CITY OF KELOWNA

MEMORANDUM

Date: September 06, 2018
File No.: Z18-0097
To: Urban Planning Management (KB)
From: Development Engineering Manager (JK)
Subject: 1354 Rutland Rd N RU1 to RM3

Site Plan

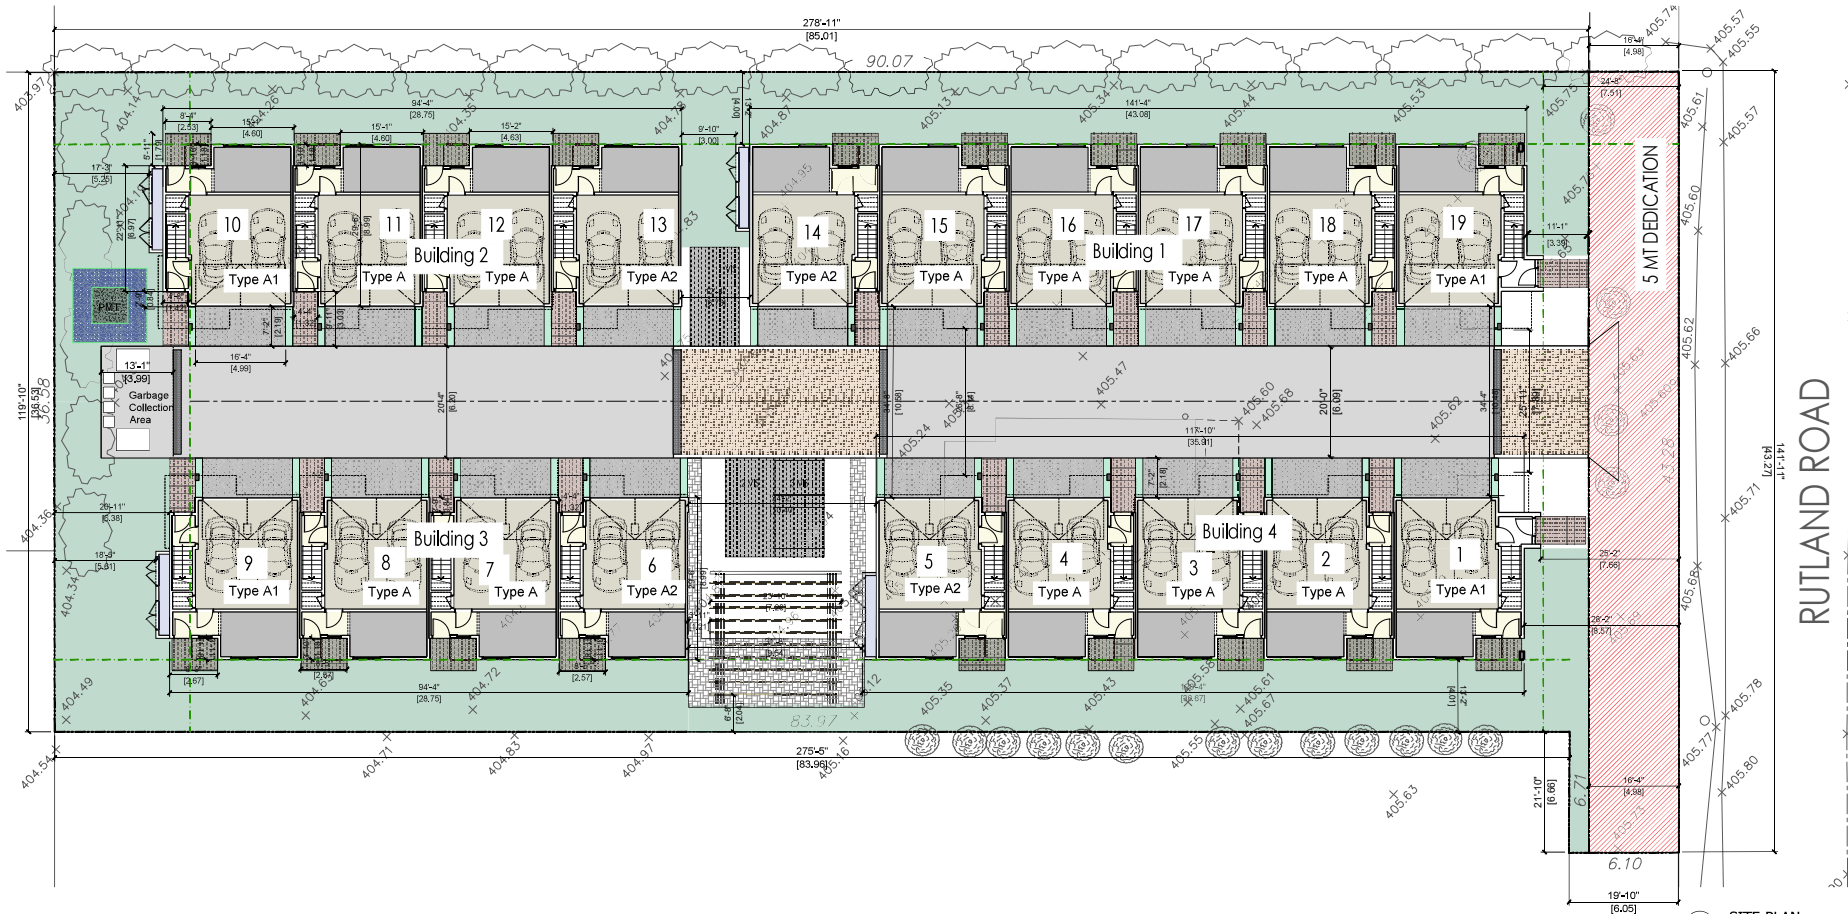
- a) Rutland Road North is identified in the OCP Transportation Servicing Plan as a 4-lane arterial with an active transportation component. Road Cross section SS-R11 is to be used.
- b) The applicant must have a civil engineering consultant submit a design for roadway improvements along the entire frontage of the subject properties. This will include curb and gutter, sidewalk, street lighting, landscaped boulevard, storm drainage system, pavement removal and replacement and re-location or adjustment of utility appurtenances if required to accommodate the upgrading construction. An estimate for public side works will be required, for bonding purposes, to be submitted by the applicants civil engineering consultant.
- c) This development application will be limited to one, maximum 6m wide, access to Rutland Rd N..

- a) Provide 5m of road dedication along Rutland Road N.
- b) Grant statutory rights-of-way if required for utility services.

- (i) Ensure acceptable turning movements onsite for MSU design vehicle.
- (ii) Any bicycle racks included with this development shall be onsite.
